SUBJECT: TRIP SUMMARY - MARK I CONTAINMENT LONG TERM PROGRAM
PLANT UNIQUE ANALYSIS REPORT (PUAR) EVALUATIONS

Re: Dresden Units 2/3, Quad Cities 1/2, Monticello
and Duane Arnold

MARK I PLANT UNIQUE ANALYSIS REVIEW

RESOLUTION OF NRC QUESTIONS

Figure 1
 RHR AND CORE SPRAY DISCHARGE N210A/N211A
 (Truncated Model)

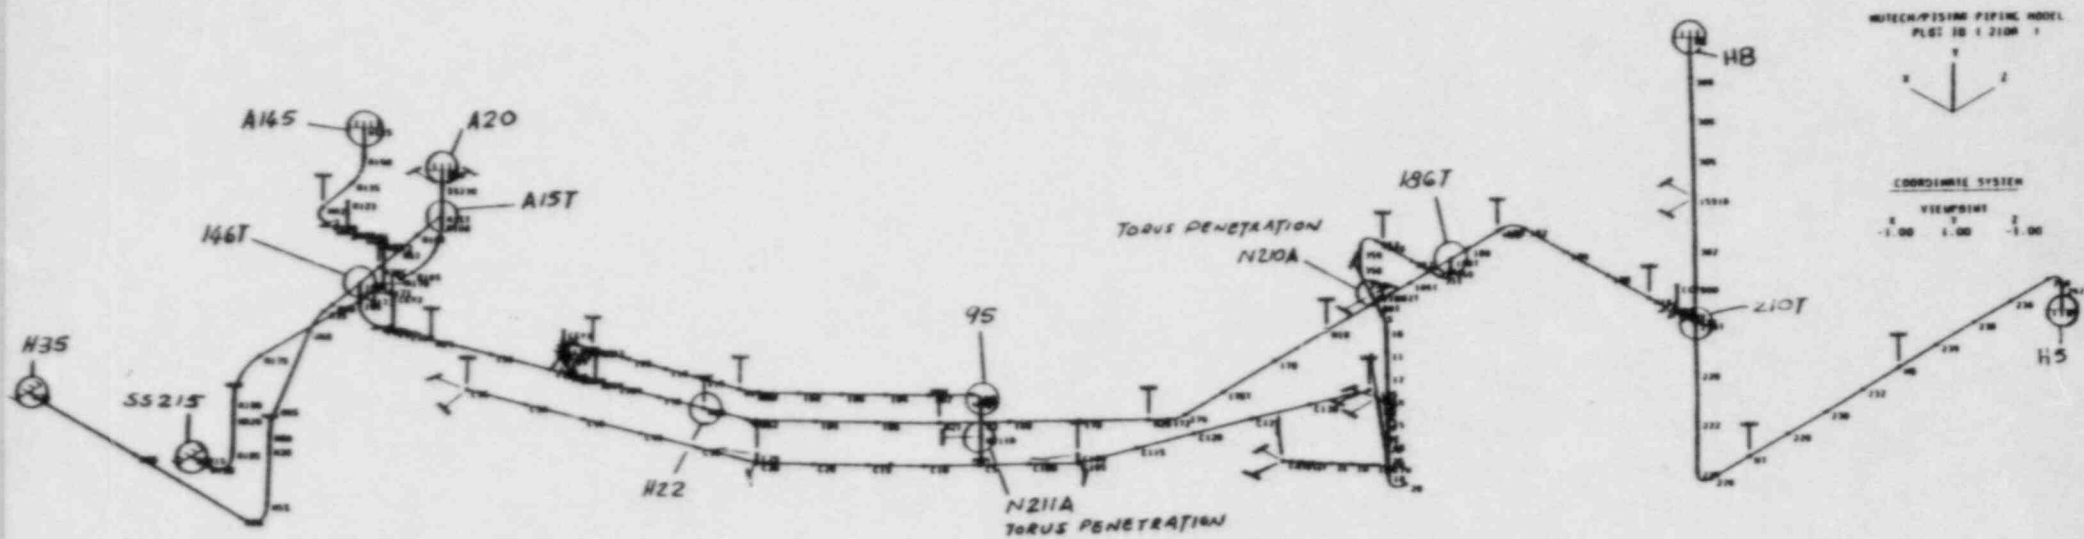
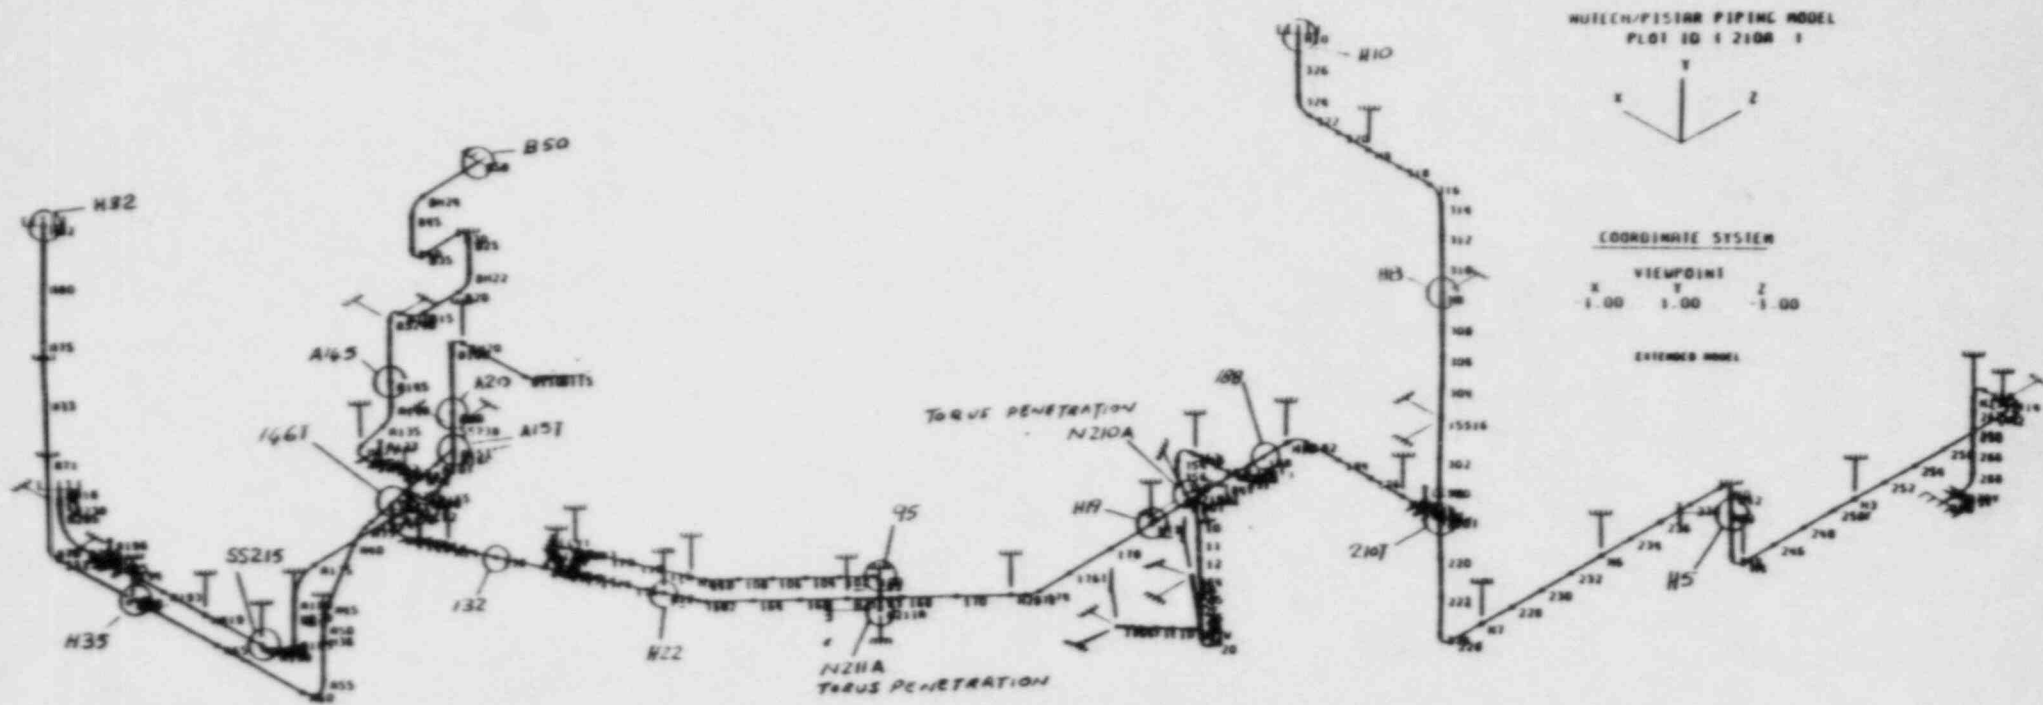
ITEM 1:

- 0 PROVIDE PLOTS OF LONG AND TRUNCATED MODELS
- 0 TREATMENT OF BOUNDARY CONDITIONS

RESPONSE TO ITEM 1:

- 0 LONG MODEL UTILIZED FOR NON-MARK I
- 0 TRUNCATED MODEL UTILIZED FOR MARK I
- 0 COMPARISON OF TWO MODELS SHOWS GOOD COMPARISON
- 0 BOUNDARIES BEYOND 10% POINT, TREATED AS FICTITIOUS ANCHORS

DUANE ARNOLD ENERGY CENTER
RHR CORE SPRAY RELIEF LINE N210B □ N211B
FORCE TRANSFER FUNCTIONS
NODE (310T) Y-MOMENT

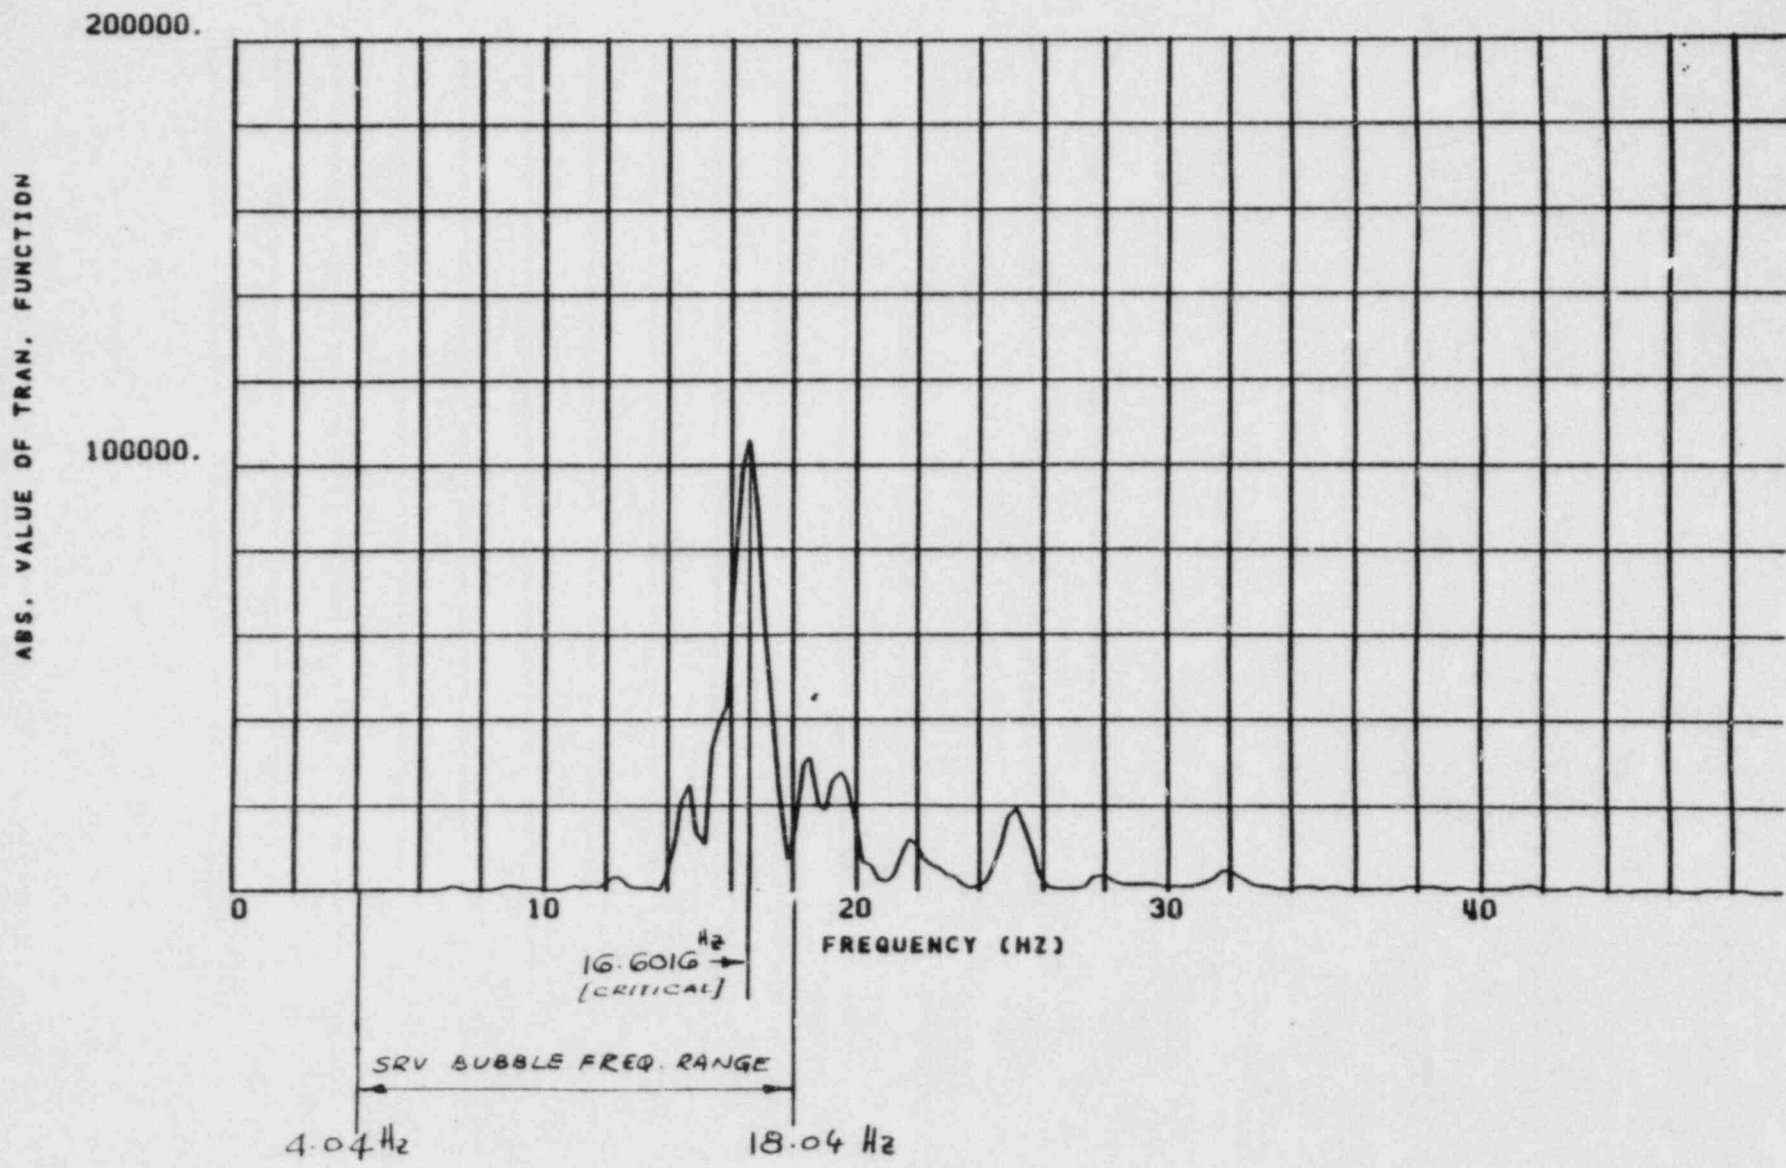
ITEM 3D

- 0 SELECT TYPICAL PIPING SYSTEM AND DEMONSTRATE METHOD OF SELECTING CRITICAL FREQUENCIES

RESPONSE TO ITEM 3D:

- 0 CRITICAL FREQUENCY CHOSEN USING TRANSFER FUNCTION PEAKS
- 0 RHR AND CORE SPRAY LINE N210B/N211B
- 0 CRITICAL FREQUENCIES:

Using this table, a check is made to confirm that the selected frequencies are critical for the response components/locations in the system.

Also, the transfer functions are typically plotted to visually confirm the selection of the critical frequencies. As an example, the transfer function plots for the stress resultant moment component at Node 310T of element 48 are provided.

RING GIRDER MODELED AS RECTANGLE

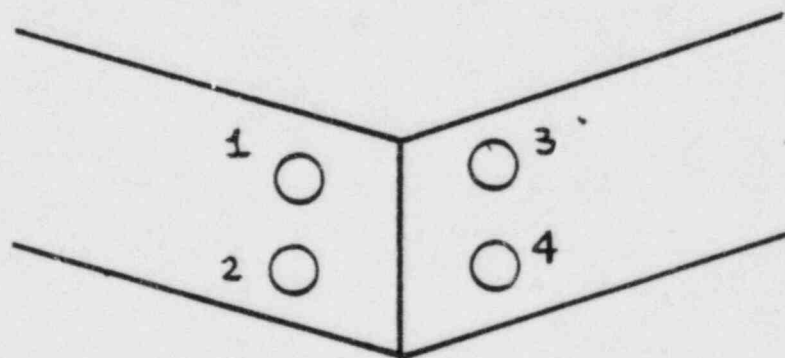
ITEM 1:

- 0 ACCELERATION VOLUMES FOR RING GIRDER
- 0 IDENTIFY CHUGGING DOWNCOMERS AND PHASING
- 0 PROVIDE LOCAL ACCELERATIONS

RESPONSE TO ITEM 1:

- 0 SAME MODELING TECHNIQUE EMPLOYED TO CALCULATE ACCELERATION VOLUMES AS PRESENTED IN ENRICO FERMI PUAR AND ACCEPTED BY USNRC
- 0 FOR IN-PLANE DIRECTION . . .

0 FOR OUT-OF-PLANE DIRECTION . . .

$$V_{\text{DRESDEN}} = [1.33 \pi A^2 + (2B-c) c + 2Ac] L A_w$$

$$V_{\text{DRESDEN}} = 59.85 \text{ FT}^3 \text{ (SECTIONS 7-10)}$$

$$V_{\text{QUAD CITIES}} = [1.207 \pi A^2 + (2B-c) c + 2Ac] L A_w$$

$$V_{\text{QUAD CITIES}} = 66.38 \text{ FT}^3 \text{ (SECTIONS 7-10)}$$
